PHASE 1 SCHEMATIC DESIGN

NSW DEPARTMENT OF
EDUCATION

NORTH SYDNEY PUBLIC
SCHOOL

SEC. 4.55 MODIFICATION ITEMS

1 ELEVATION
BUILDING I - EAST ELEVATION
SCALE: 1:100

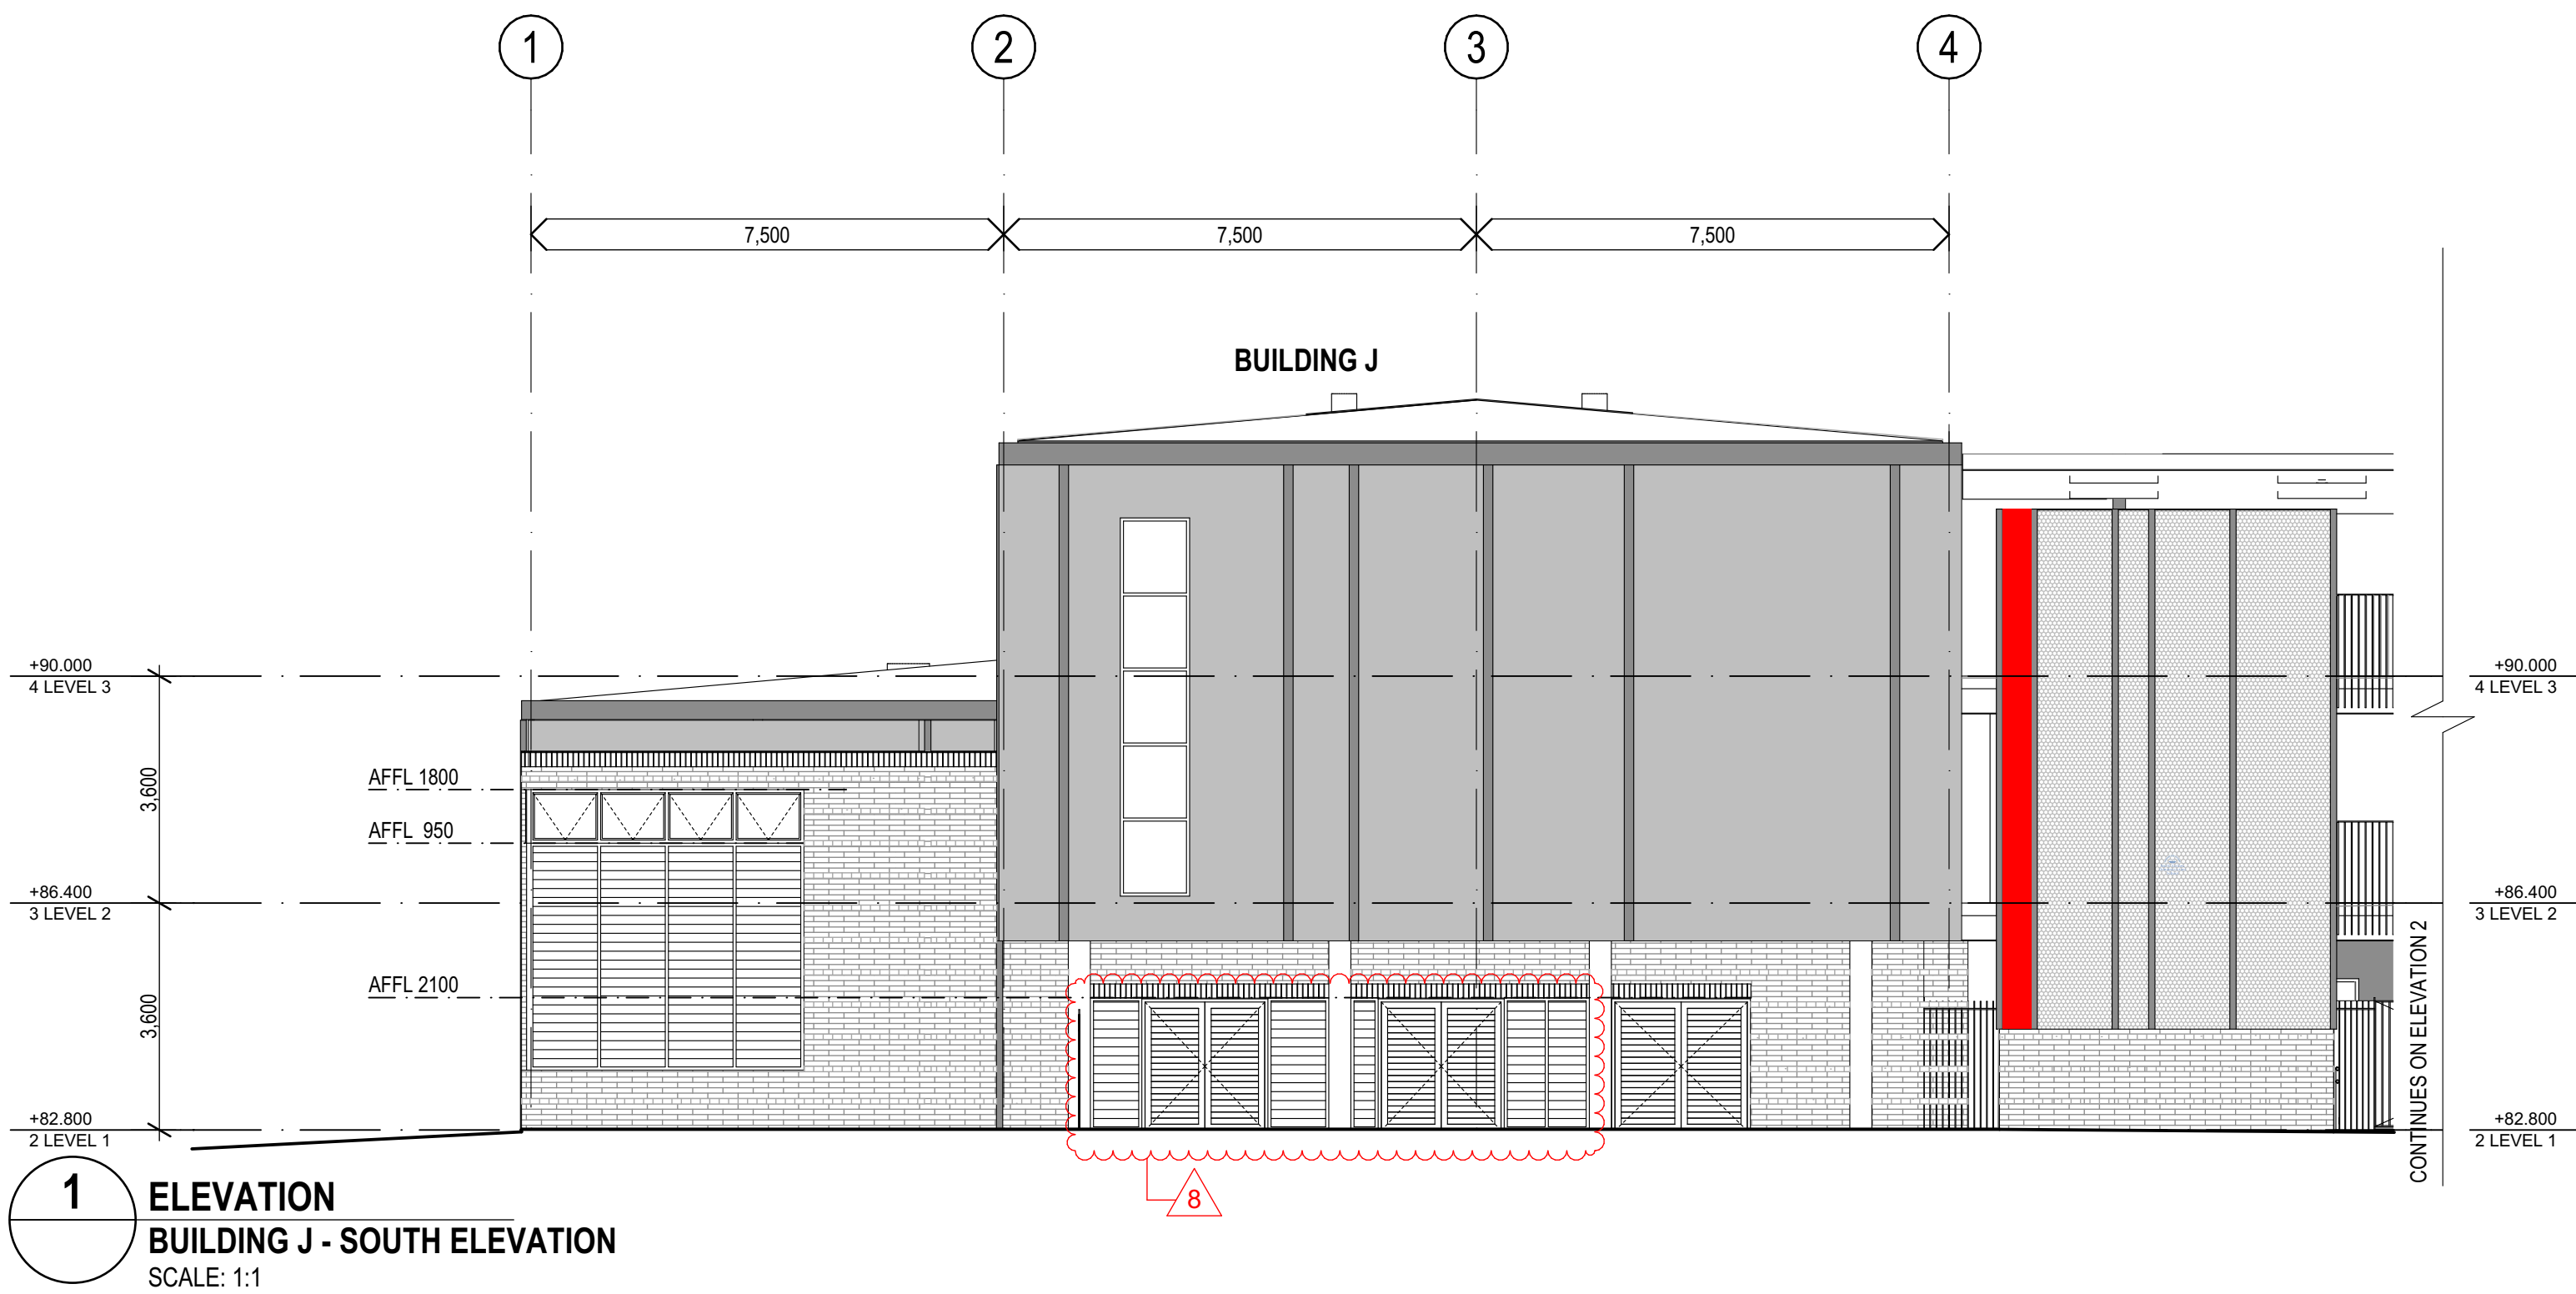
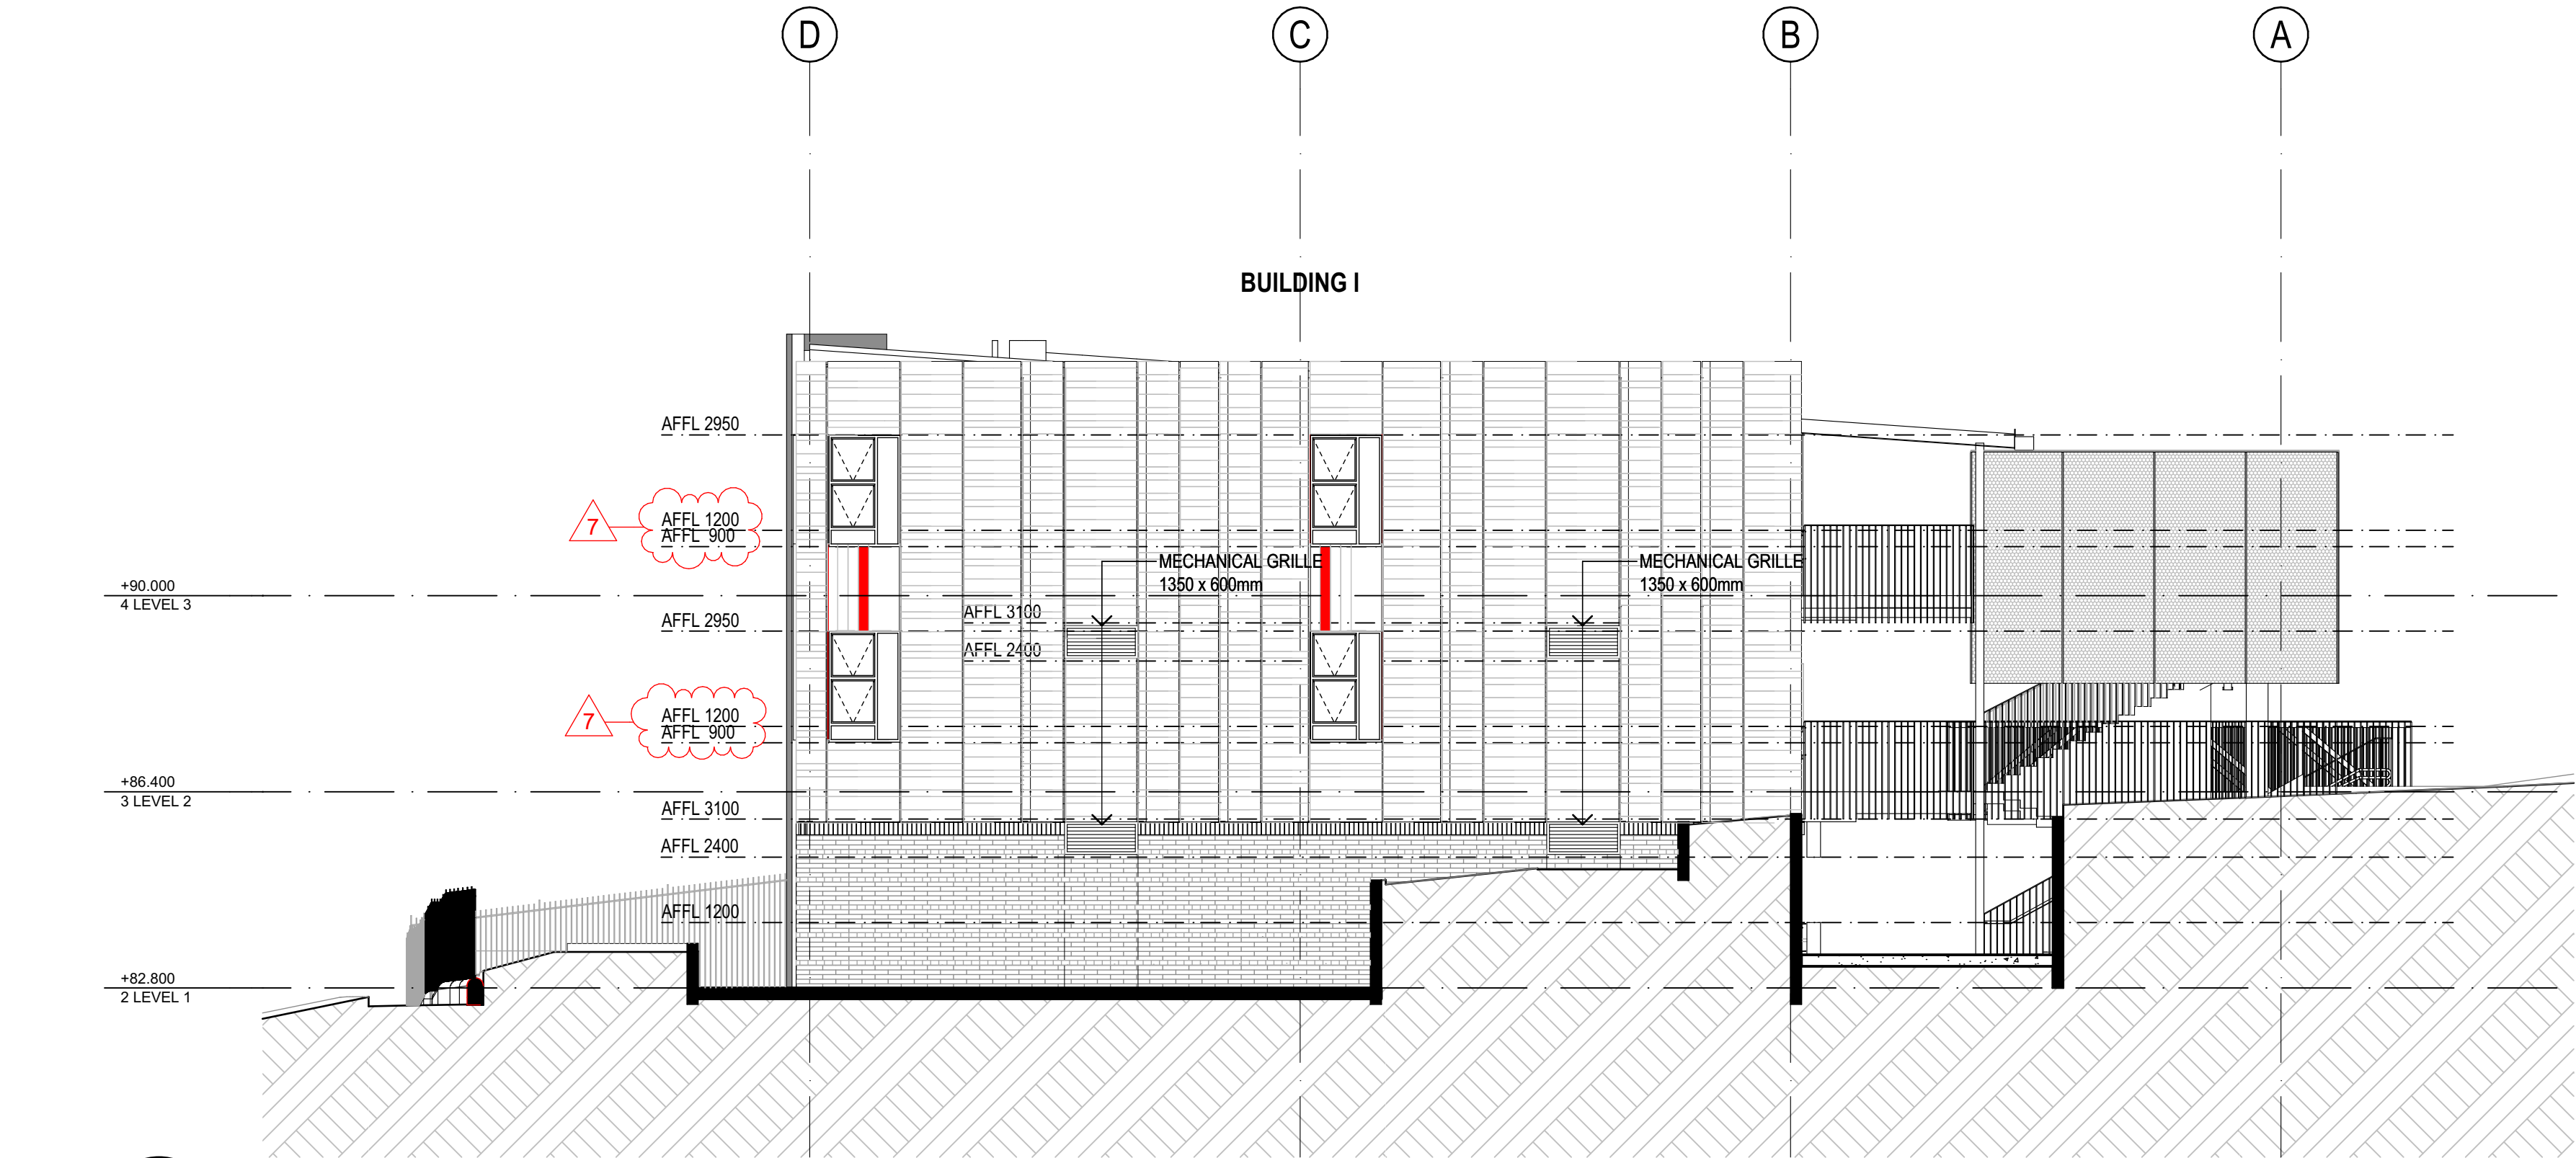
- ENTRY RAMP RECONFIGURATION TO BE 1:15, ADDITIONAL SLAB TO ACCESS PLANT ROOM
- HERITAGE FENCE TEMPORARY REMOVAL
- ADDITIONAL CLEANER'S CUPBOARD
- LIBRARY ENTRY DOOR MOVED DUE TO CLEANER STORE BEING ADDED, NOW ALIGNS WITH LIFT
- WALL ALIGNMENT OF WC'S LEVEL 3
- WINDOW CHANGES TO BUILDING I SOUTH & EAST ELEVATIONS ON L1 / L2 / L3. WINDOWS INCREASED IN SIZE FOR COMPLIANCE WITH BCA PART F4 - LIGHT AND VENTILATION. FIXED GLAZED PANEL INTRODUCED TO LOWER SECTION OF L2 / L3 WINDOWS TO MEET MIN 1200MM SILL HEIGHT REQUIREMENT IN EFSG. LARGER OPENABLE AWNINGS INTRODUCED FOR NATURAL VENTILATION COMPLIANCE.
- LOUVERED DOORS CHANGE FROM SINGLE TO DOUBLE DOOR TO SUIT PLANT ROOM REQUIREMENTS.
